RE: Kattenburg Pit M-2004-017
Technical Revision – Updates to Mining and Reclamation Plans
Adequacy 2 Response

Attached is a response to your second adequacy review of TR02 for the Kattenburg Pit. Each section is addressed and revised maps and exhibits are included as necessary. Adequacy items addressed previously have been omitted for clarity

Figure G-1. Neighboring Wells

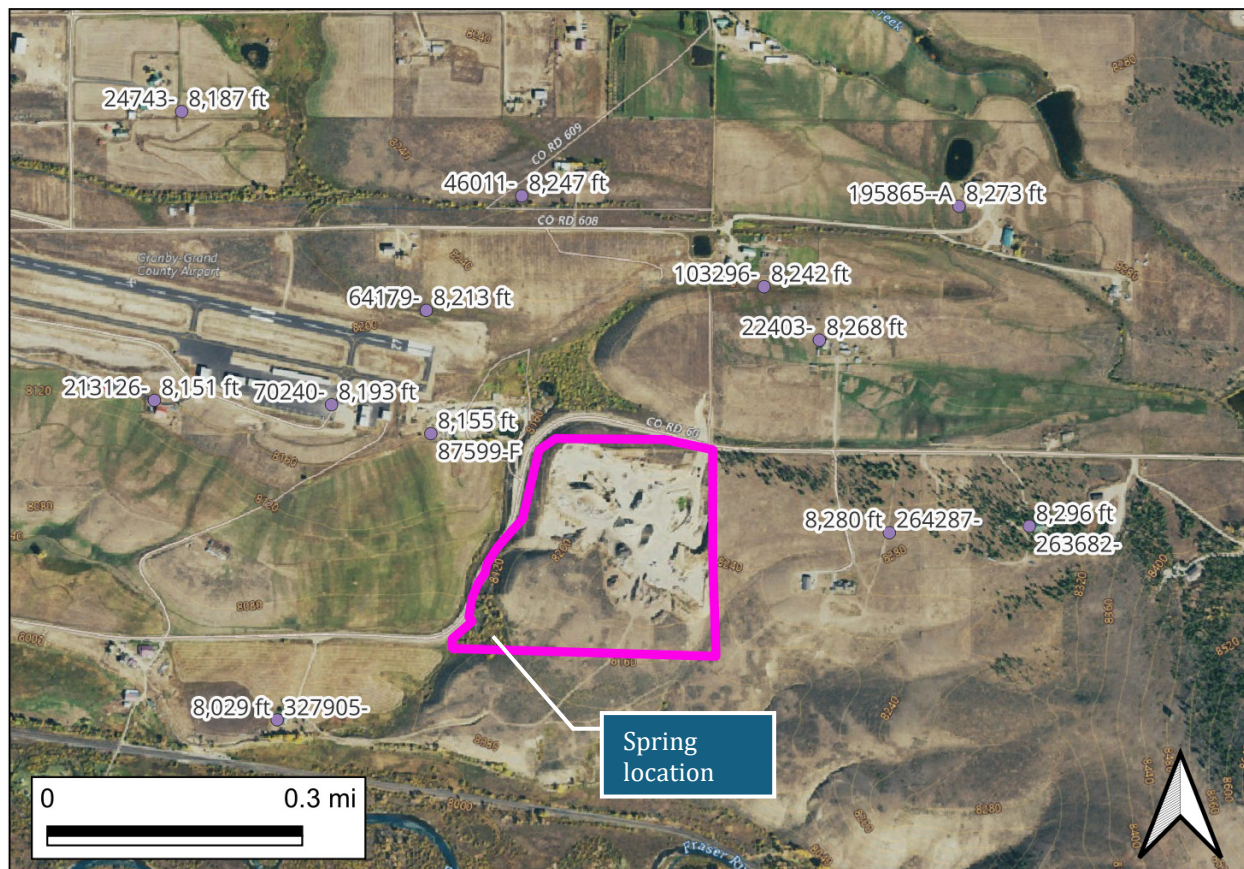
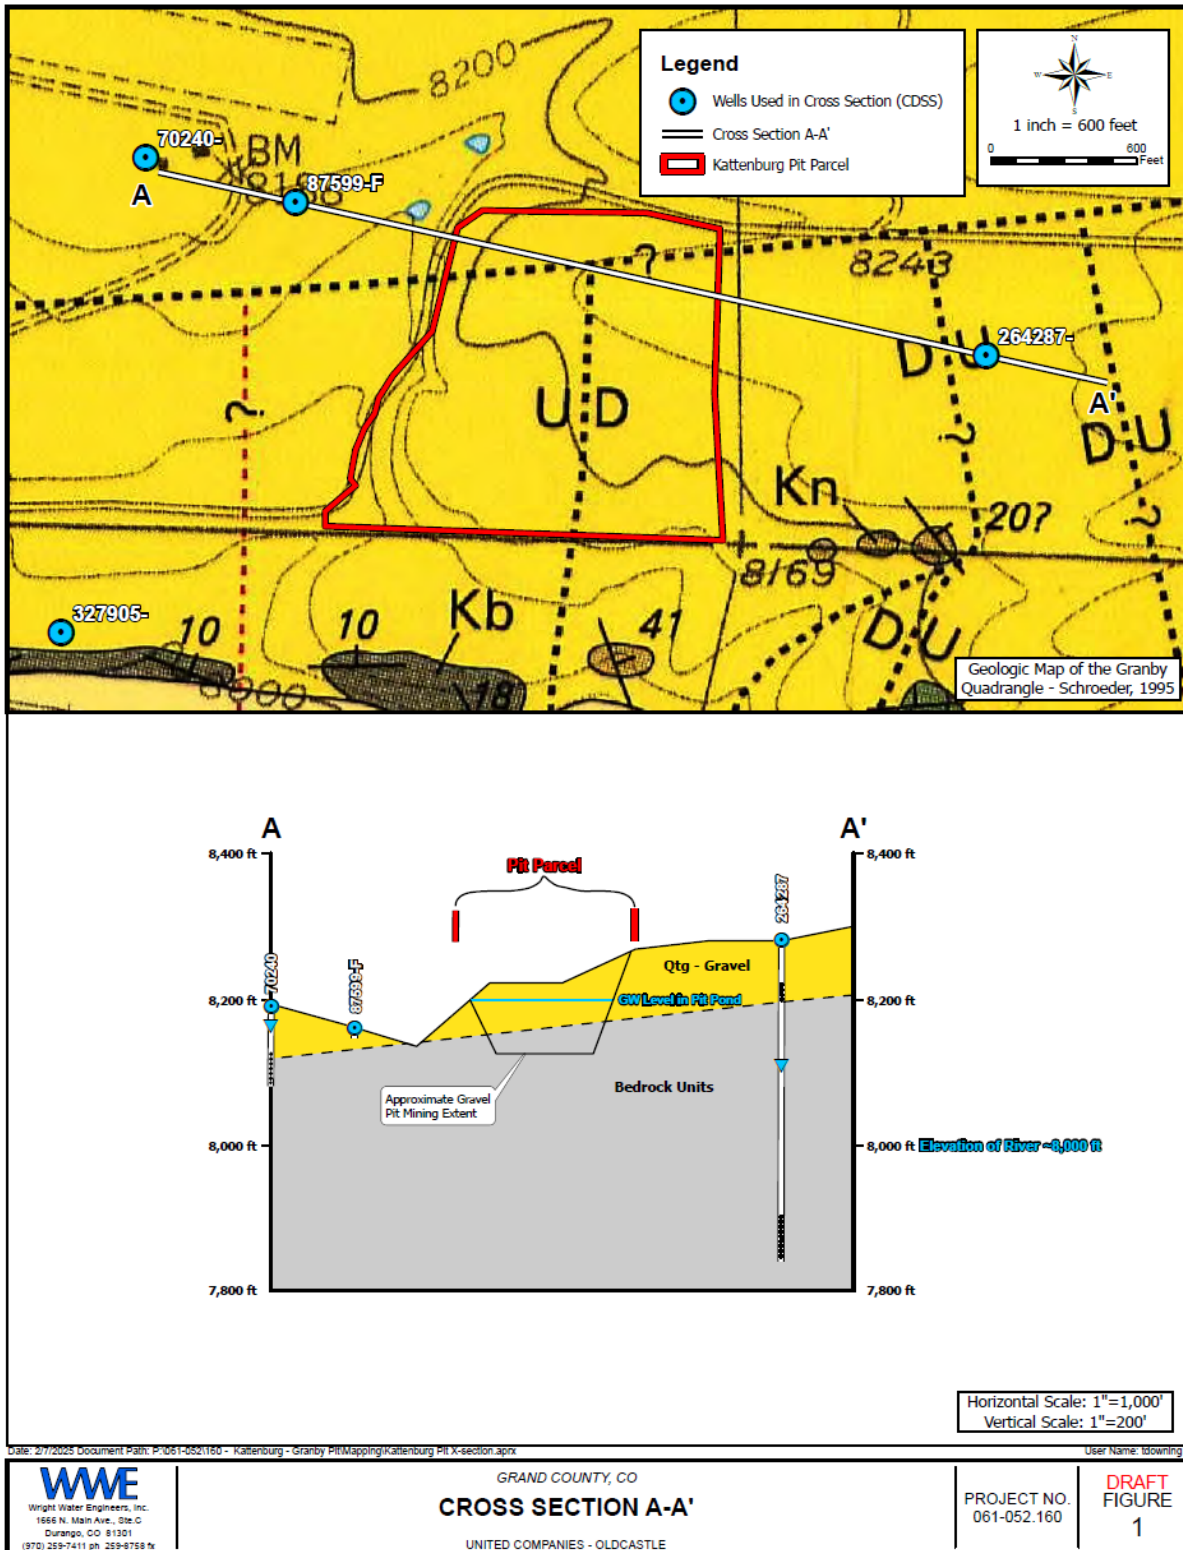
Rule 6.4.7 Exhibit G Water Information

Exhibit G has been revised with substantial additional information to address the adequacy questions listed. The additional information specifically addresses why groundwater monitoring is not necessary at the Kattenburg Pit. Well elevations are shown on appropriate figures. Underlying aquifers are addressed. Lack of material saturation is discussed. Potentiometric surfaces are addressed. The likely spring located to the southwest of the site is addressed. Wright Water Engineers addresses all water consumption in the substitute water supply plan (SWSP). Long term water supply is addressed.

Appendix G-2 has been added to the permit to contain the SWSP and gravel well permit (89564-F, replacing 88710-F) for the 0.1 acre groundwater exposure. All gravel is assumed to be mined above the water table, since the groundwater pond (0.1-acres) is maintained below the working floor throughout the mine life. This eliminates the need to track whether gravel is mined below the groundwater table or not.

Groundwater has been encountered in the pit at a depth of 25-feet below the original ground level. A nearby well (87599-F) shows groundwater at a depth of 1-foot, near the airport to the west. Said well has a collar elevation at least 100-ft below the Kattenburg Pit. A 57-foot deep groundwater value is located in well 22403, which is northeast of the pit. This well is a domestic supply well installed in 1964 and may not be an accurate representation of the gravel aquifer passing through the area. The other nearest well (to the east), 264287, has a water level of 180-feet. However, Well 264287 is installed in the shale below the local sand and gravel deposit and is thus not an accurate representation of groundwater in the sand and gravel that is being mined. Figure G-1 shows the neighboring and nearby wells based on Colo. Div. of Water Resources records. Well 89564-F is the gravel well for the water exposure at Kattenburg.

The sand and gravel deposit that Kattenburg is mining daylights to the south and west sides of the site. As such, there are no wells to the south in the same alluvium. Based on the surrounding well data and the geologic/topographic conditions of the site, it is clear that the groundwater at the Kattenburg Pit is in a perched aquifer that exists between the uphill irrigation infiltration and the downstream springs immediately southwest of the pit. The water level in the sand and gravel likely varies with the irrigation season; no potentiometric surface can be assumed or established. The level of saturation is unknown. The spring location coincides with the road ditch, creating a wet area as shown on Figure G-1. The spring has not been field located and no flowrate is known. Its co-location with the road side ditch makes location of the exact spring problematic. Figure G-2 shows a cross section concept of the groundwater conditions at the Kattenburg Pit.

Since the groundwater at Kattenburg is fed by irrigation infiltration and then readily drains out through a spring, this groundwater cannot be reliably studied. Given the limited scope and supply of the groundwater at Kattenburg, a groundwater monitoring plan is both impractical and

ultimately unnecessary. As such, no groundwater monitoring plan will be conducted at the Kattenburg Pit.
